# ROOF TRUSS FRAMING

Bennett Resident

ROOF TRUSS PLACEMENT PLAN

PROJECT NUMBER
24090120

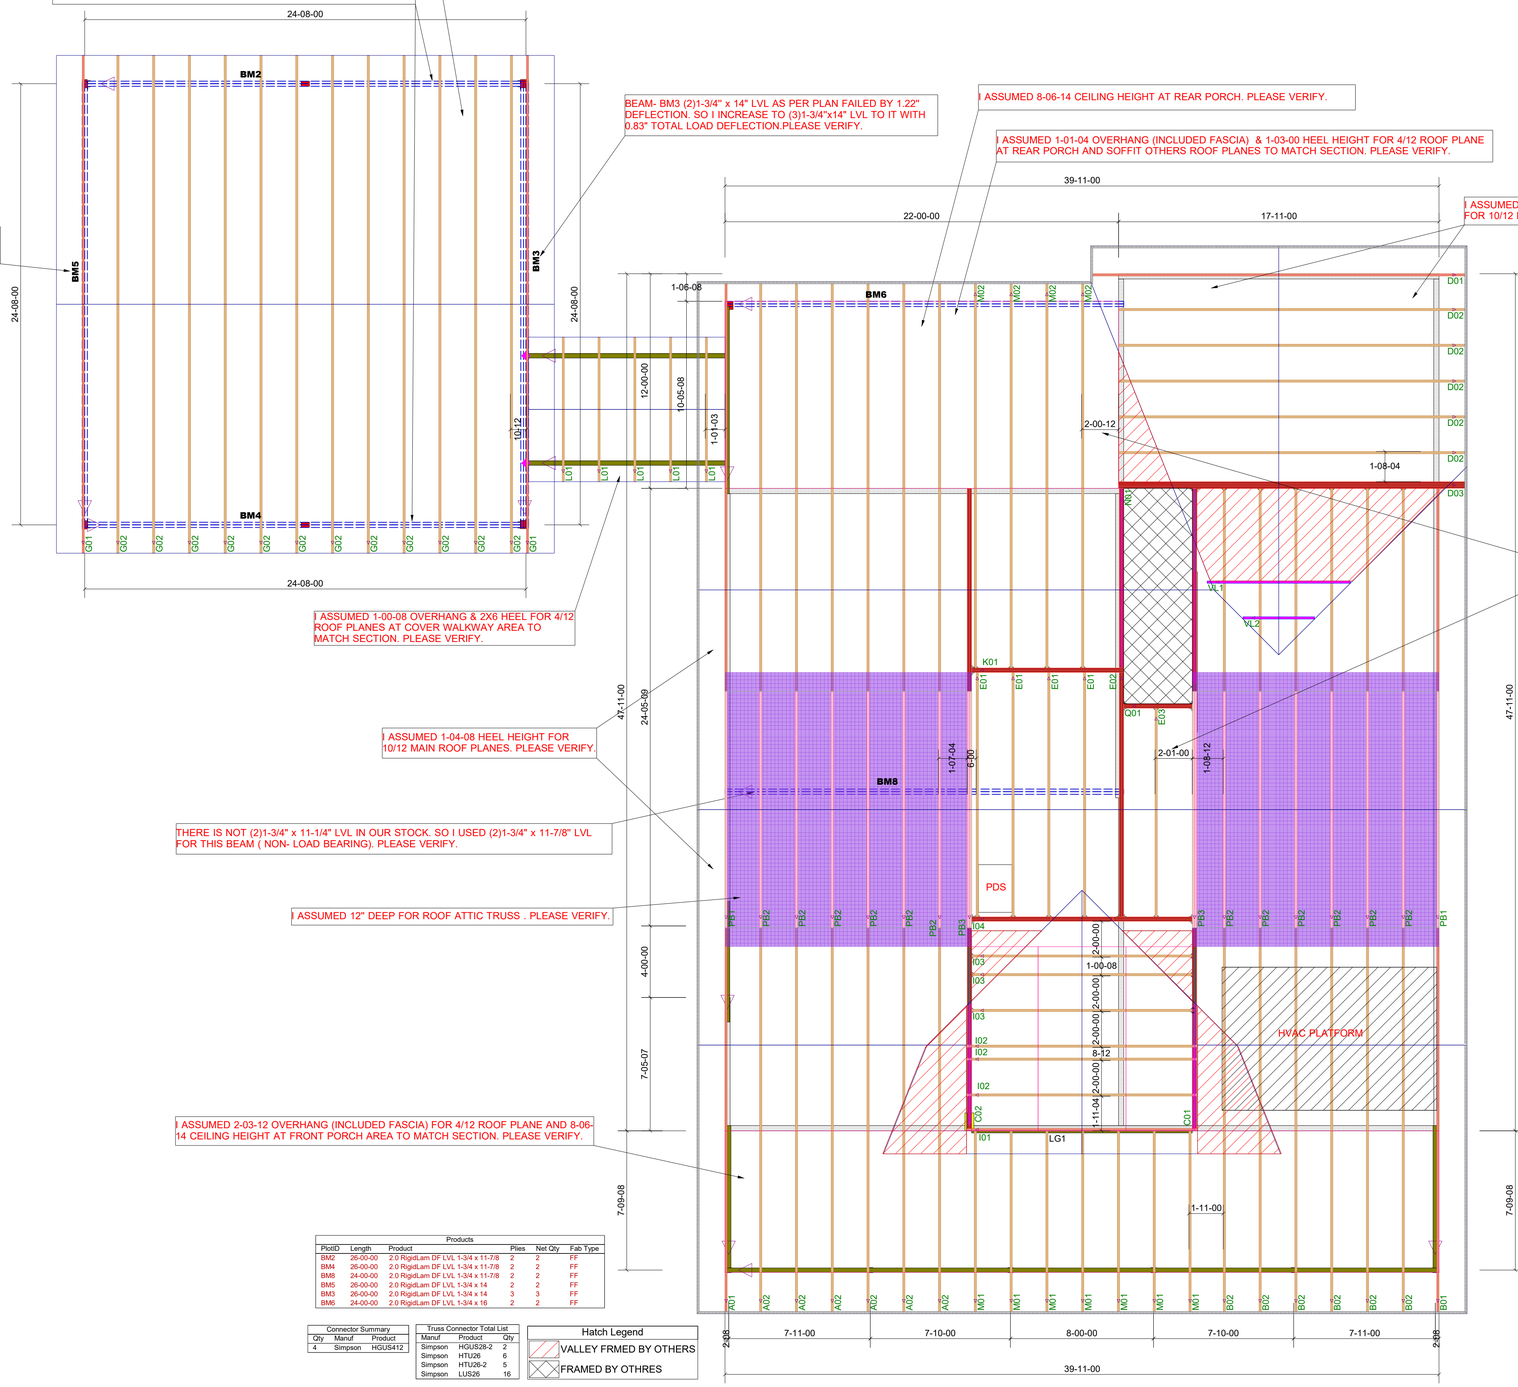
I ASSUMED 1-07-00 OVERHANG & 2X6 HEEL FOR 4/12 ROOF PLANES AT CAR PORT AREA TO MATCH SECTION. PLEASE VERIFY.

THERE WERE NO BEAMS (2)1-3/4" x 11-1/4" LVL IN OUR STOCK. SO I USED (2)1-3/4" x 11-7/8" LVL FOR THESE BEAMS. PLEASE VERIFY.

BEAM- BM3 (2)1-3/4" x 14" LVL AS PER PLAN FAILED BY 1.22" DEFLECTION. SO I INCREASE TO (3)1-3/4"x14" LVL TO IT WITH 0.83" TOTAL LOAD DEFLECTION.PLEASE VERIFY.

I ASSUMED 8-06-14 CEILING HEIGHT AT REAR PORCH. PLEASE VERIFY.

I ASSUMED 1-01-04 OVERHANG (INCLUDED FASCIA) & 1-03-00 HEEL HEIGHT FOR 4/12 ROOF PLANE AT REAR PORCH AND SOFFIT OTHERS ROOF PLANES TO MATCH SECTION. PLEASE VERIFY.

I ASSUMED 1-06-12 OVERHANG (INCLUDED FASCIA) FOR 10/12 ROOF PLANES. PLEASE VERIFY.

BEAM- BM5 (2)1-3/4" x 14" WORK WITH 0.56" TOTAL LOAD DEFLECTION.PLEASE VERIFY.

I ASSUMED 1-00-08 OVERHANG & 2X6 HEEL FOR 4/12 ROOF PLANES AT COVER WALKWAY AREA TO MATCH SECTION. PLEASE VERIFY.

I ASSUMED 1-04-08 HEEL HEIGHT FOR 10/12 MAIN ROOF PLANES. PLEASE VERIFY.

THERE IS NOT (2)1-3/4" x 11-1/4" LVL IN OUR STOCK. SO I USED (2)1-3/4" x 11-7/8" LVL FOR THIS BEAM ( NON- LOAD BEARING). PLEASE VERIFY.

I ASSUMED 12" DEEP FOR ROOF ATTIC TRUSS . PLEASE VERIFY.

I ASSUMED 2-03-12 OVERHANG (INCLUDED FASCIA) FOR 4/12 ROOF PLANE AND 8-06-14 CEILING HEIGHT AT FRONT PORCH AREA TO MATCH SECTION. PLEASE VERIFY.

PLEASE VERIFY THE LOCATIONS PDS AND 8X12 SIZE OF HVAC PLATFORM.
